PROJECT NAME: TAPLEY BARN

PROJECT NUMBER: 2024020085

APPLICATION: DRC WAIVER REQUEST #31201

DEVELOPMENT REVIEW COMMITTEE WAIVER REQUEST FORM

Tapley - Owner Building
1353S-00401
1"=60'

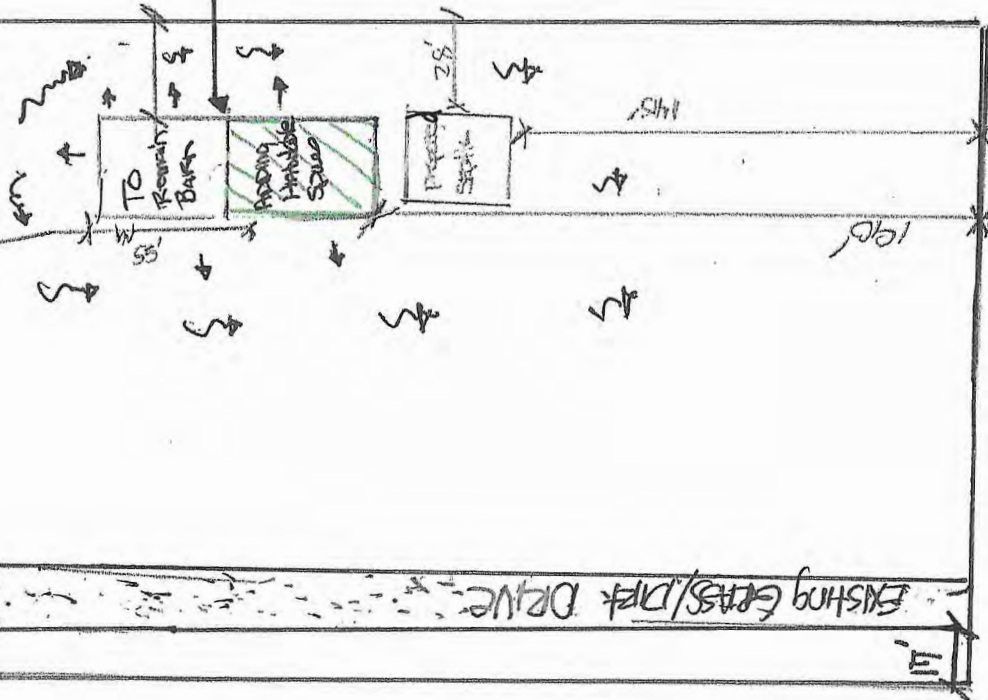
- 7 DEPARTMENT: UTIL - MARION COUNTY UTILITIES
REVIEW ITEM: LDC 6.14.2.B(2)(b)1 - Wastewater connection
STATUS OF REVIEW: INFO
REMARKS: DENIED - required to connect, or alternatively Code allows the installation of a system which meets DOH's requirements for nitrogen reduction.

- 8 DEPARTMENT: UTIL - MARION COUNTY UTILITIES
REVIEW ITEM: LDC 6.14.2.B(2)(c) - Wastewater connection
STATUS OF REVIEW: INFO
REMARKS: DENIED - connection required as this development increases the number of ERCs on this parcel from one to two.

- 15 DEPARTMENT: DOH - ENVIRONMENTAL HEALTH
REVIEW ITEM: LDC 6.14.2.B(2)(b)1 - Wastewater connection
STATUS OF REVIEW: NO
REMARKS: Per 381.0065(1)(b) F.S. and 381.0065(2)(a)1 F.S. the sewer system is available to this lot and should be connected.

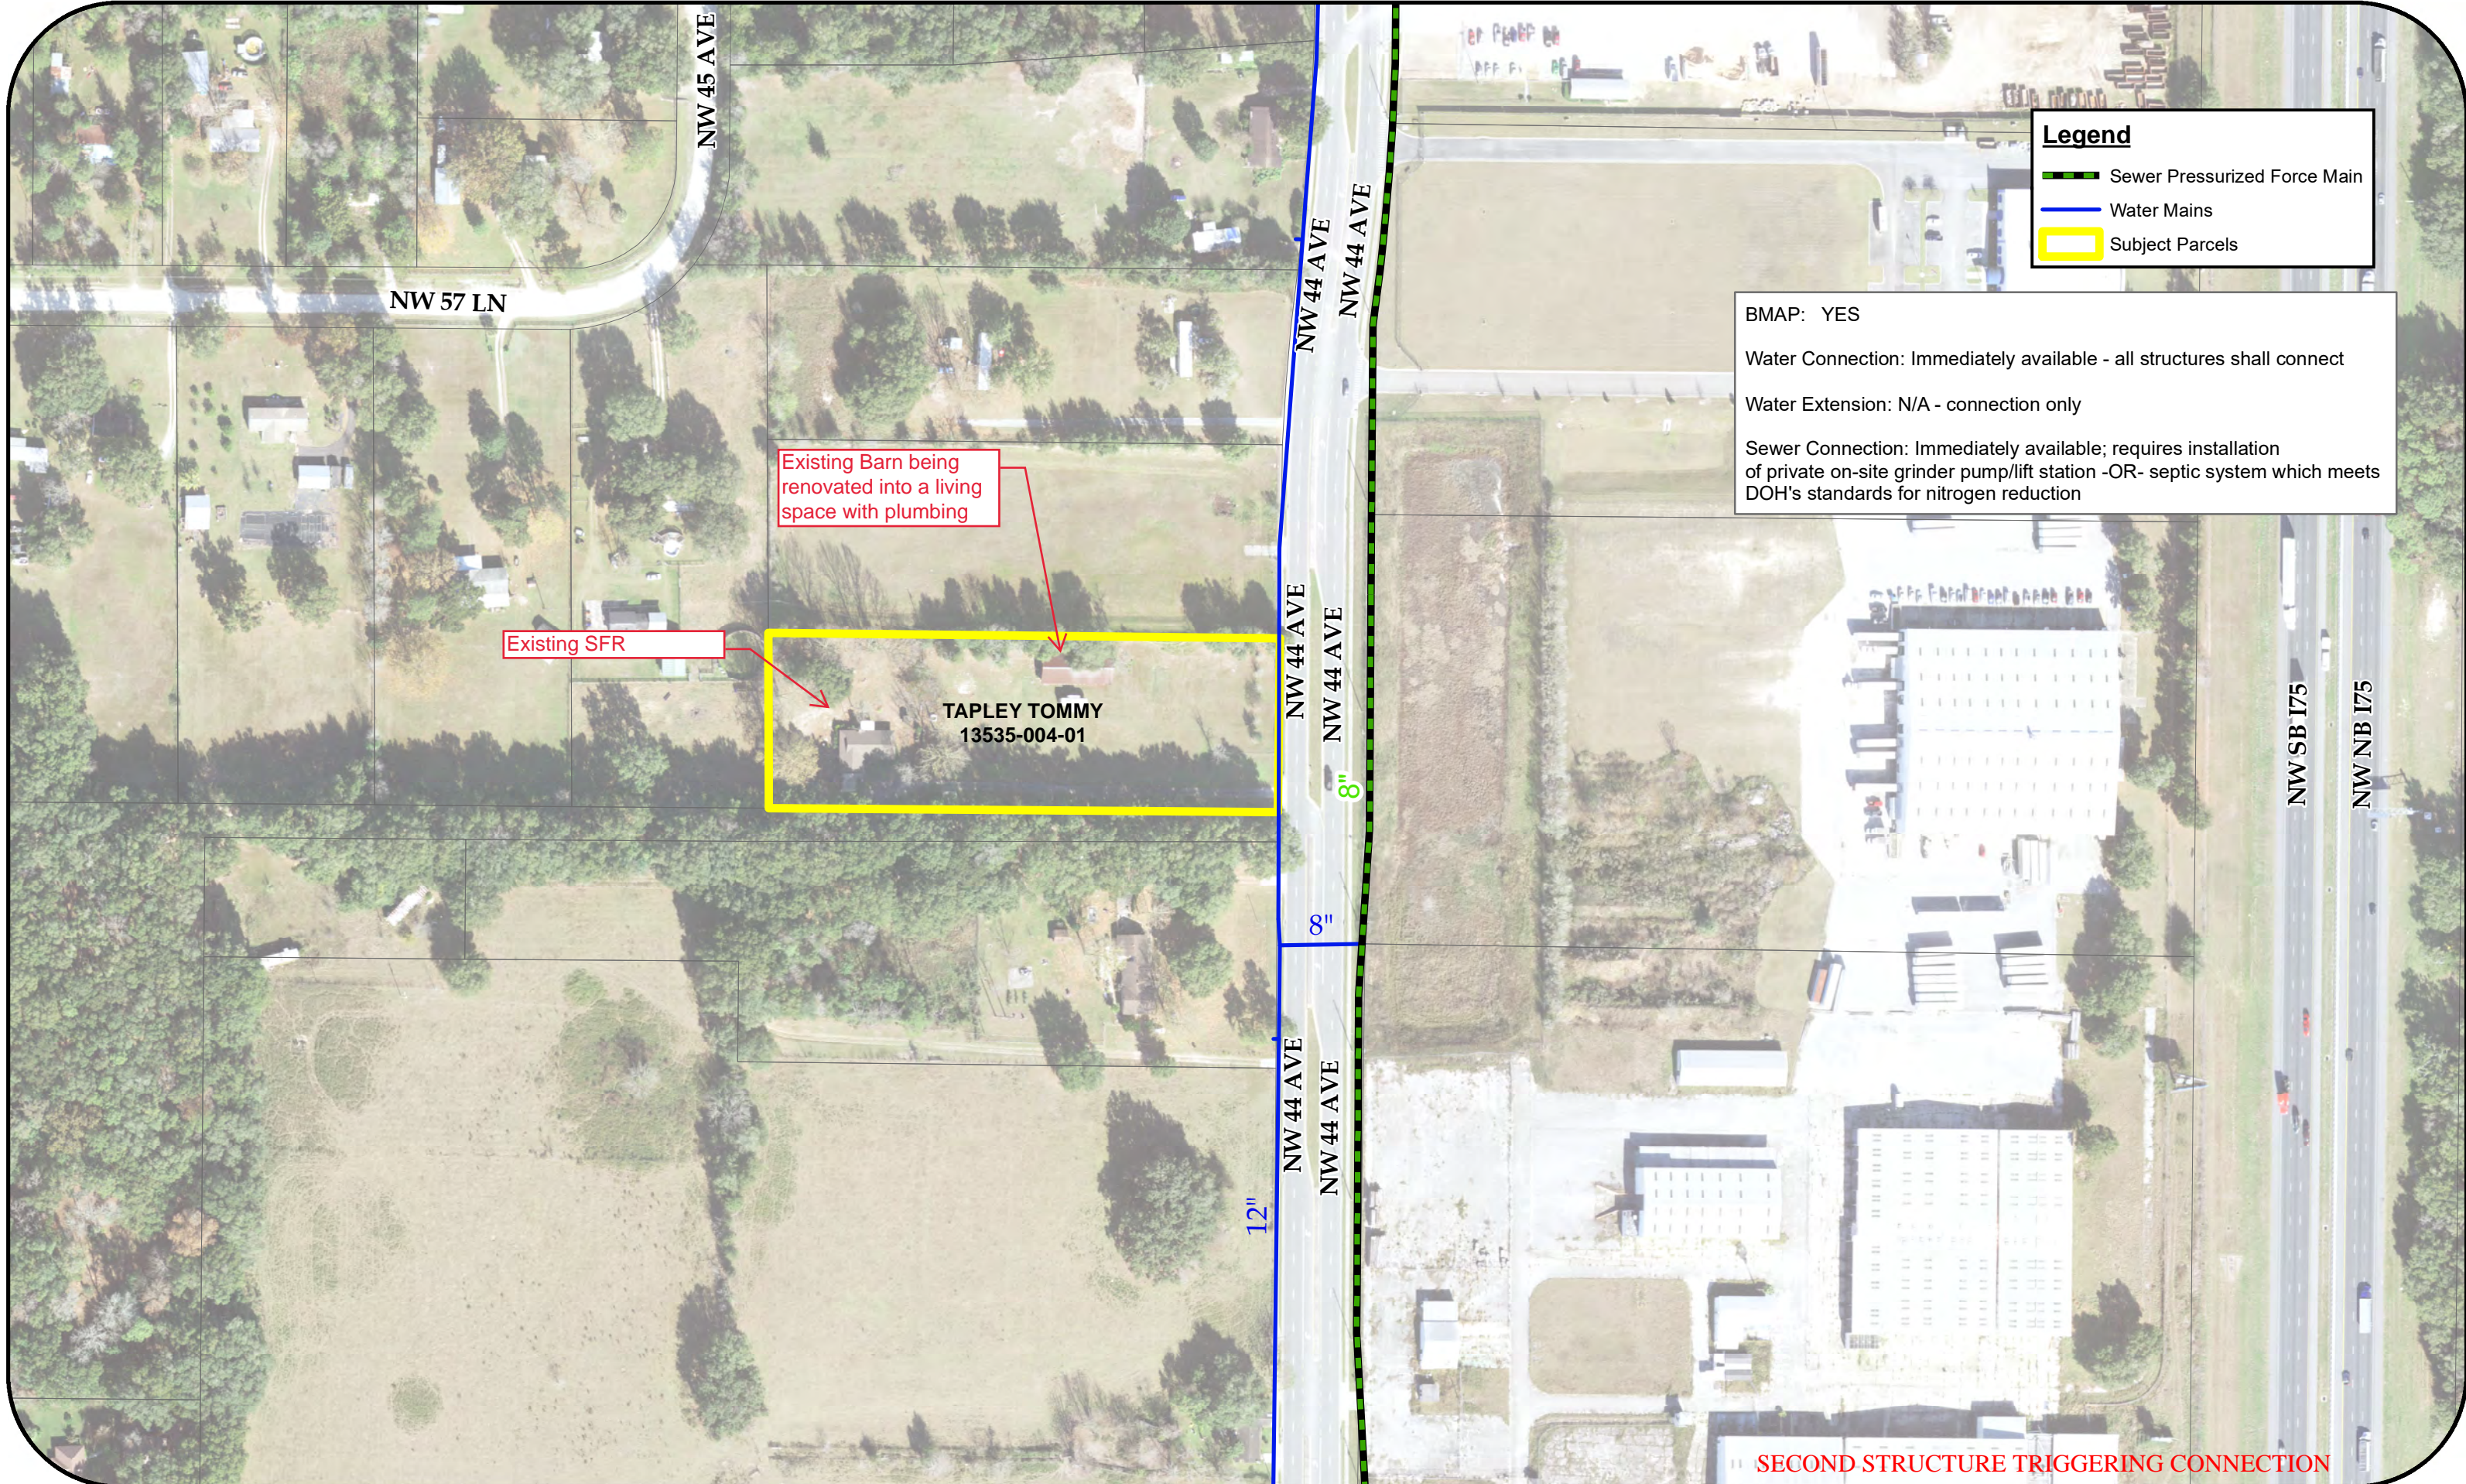
Water Connection: Immediately available - all structures shall connect

Sewer Connection: Immediately available; requires installation of private on-site grinder pump/lift station -OR- septic system which meets DOH's standards for nitrogen reduction
